Manchester Royal Infirmary

Glint and Glare Study

Subject	Addendum
Job No/Ref	314676-00
Date	15 February 2026

1. Purpose of Addendum

Figure 2 Proposed SPV layout and orientations (Patrick Cryne Building)

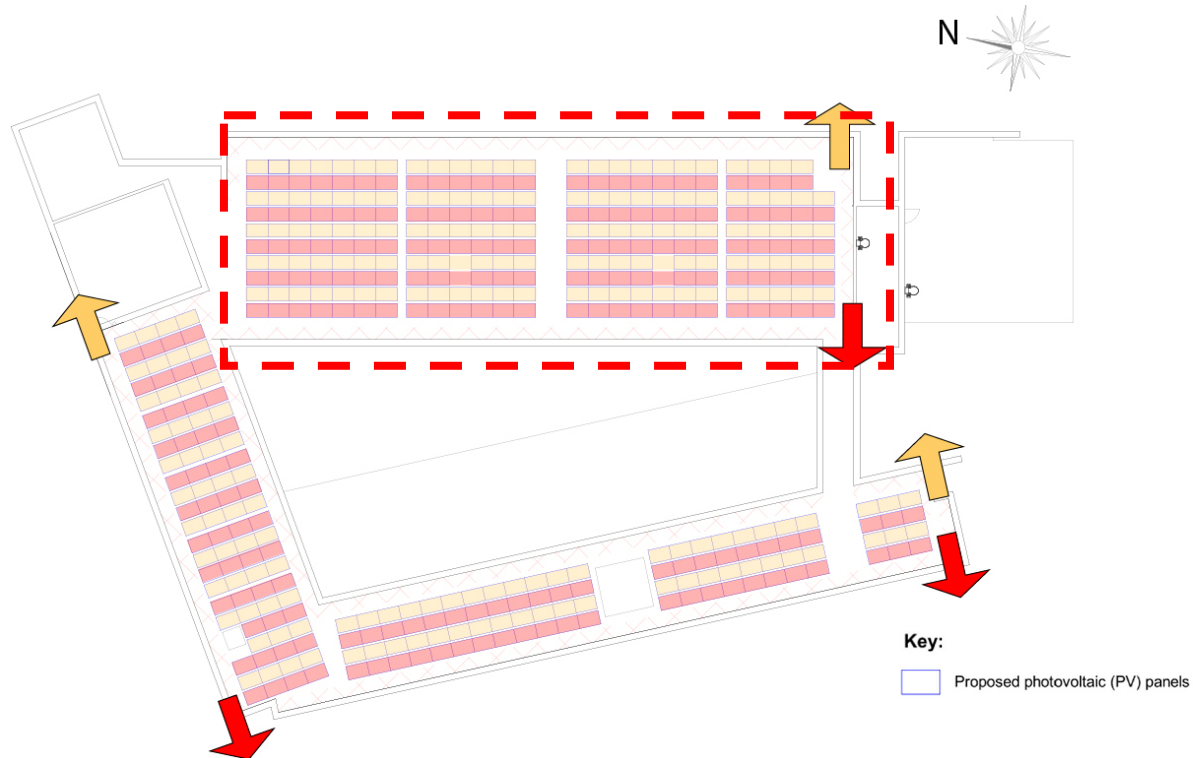
The SPV on this building comprises a triangular section arrangement (Figure 3) of SPVs arranged on three roof areas. The area resulting in the temporary after image is identified in red in Figure 2.

The SPVs causing the reflections are tilted 10° towards the west (described as PCB05 in the report appendix). The SPVs tilted 10° towards the east were not found to result in an after image (described as PCB02 in the report appendix).

Therefore, an alternative arrangement is proposed for the west facing panels. All panels will be titled 10° to the east (Figure 4) to match the performance of PCB02, which was not identified to cause an after image in the original study.

Figure 5 Revised layout plan for SPV section (Patrick Cryne Building)

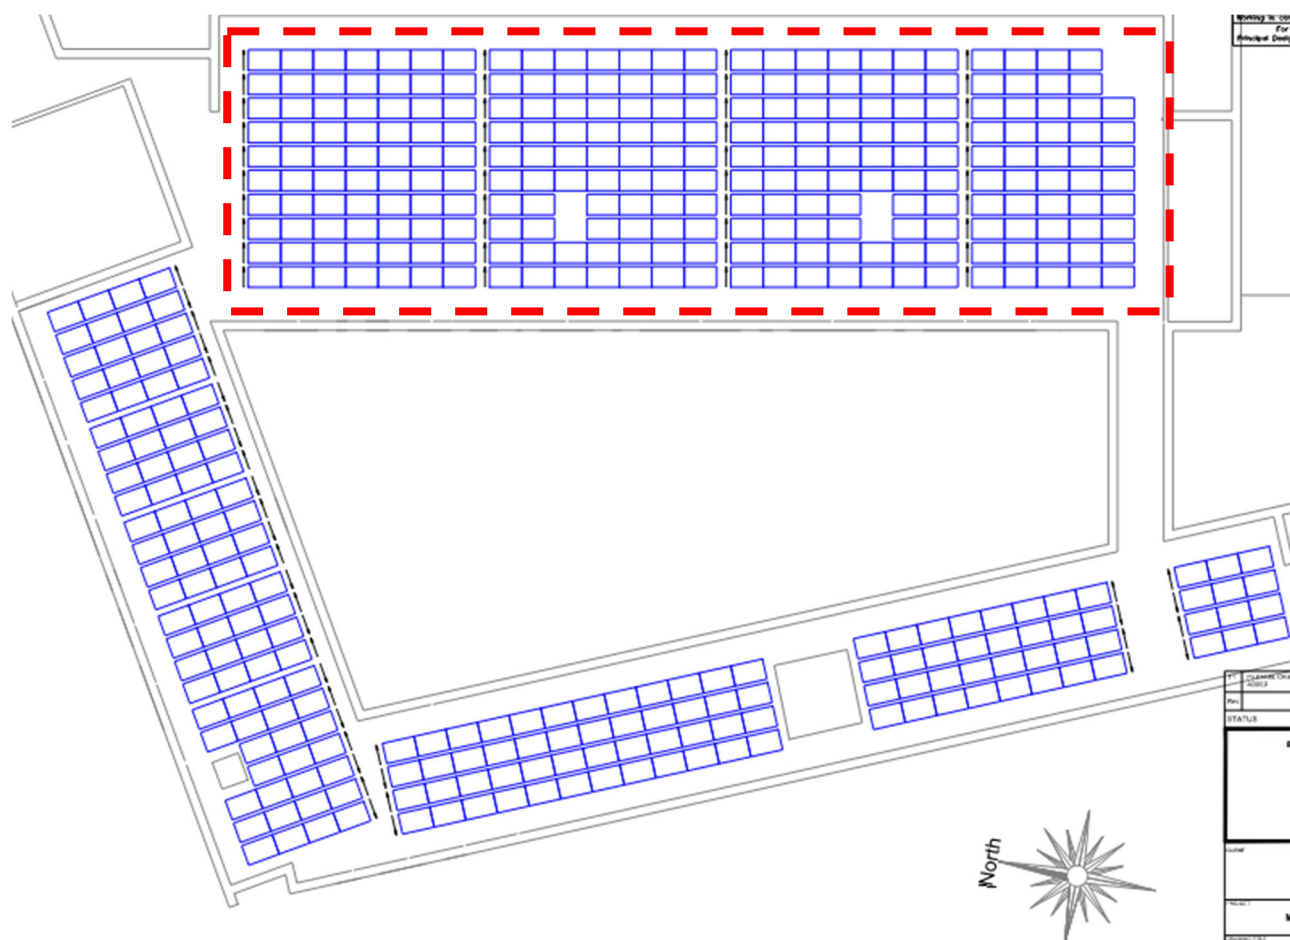
By comparison of Figure 2 and Figure 5, it can be seen that the orientation and tilt direction of the smaller areas of SPV are unchanged in the mitigated solution.

This arrangement is described on the following layout plan, Figure 5.
